Communication with TI support regarding temperature reading on PDB

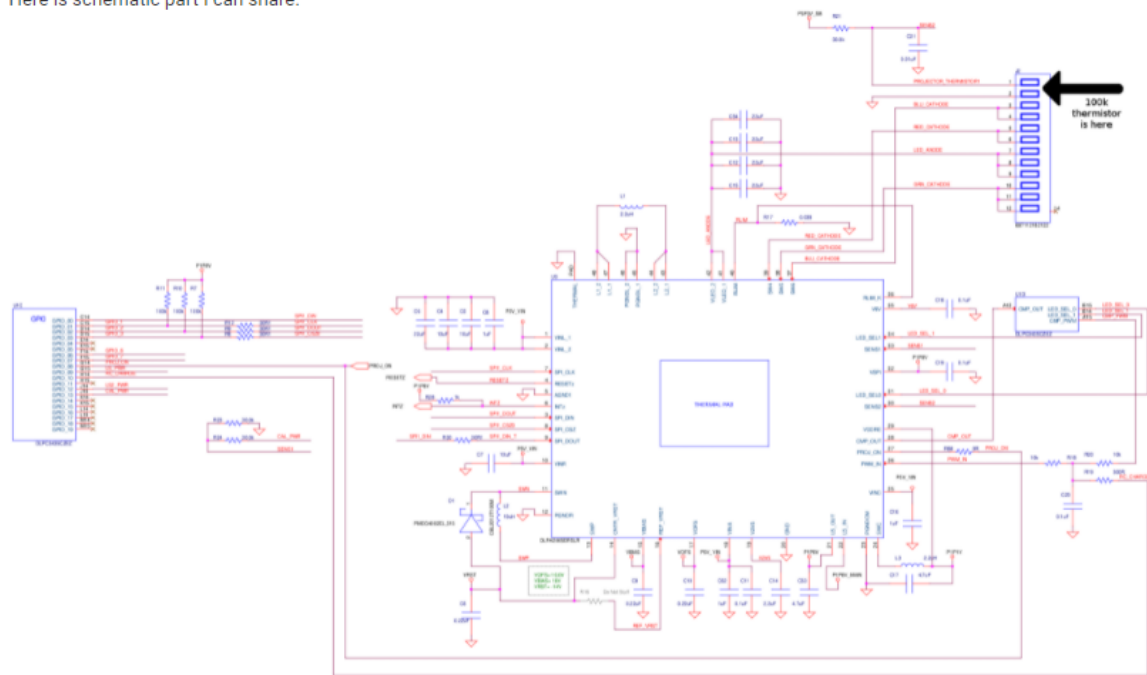
The issue is that tables you provided do not work with 30kΩ resistor and 100kΩ thermistor at 3v3.

Expected voltage for 100kΩ thermistor with this divider configuration is about 2.5 V. This is way above 1.67 V peak i can measure using oscilloscope at PWM_IN.

If i replace thermistor with 50kΩ variable resistor, i can see values changing, until i exceed RC peak voltage for comparator.

Here is schematic part i can share:

I went ahead and uploaded a new FW version to mySecure which boots the chipset to external video mode. As for your thermistor issue, I'm afraid that 3.3v drive for the thermistor circuit is not supported. You need to provide a 1.8V Thermistor Power rail (typically, this is done via the DLPC3435's GPIO) so that the comparator input does not saturate.
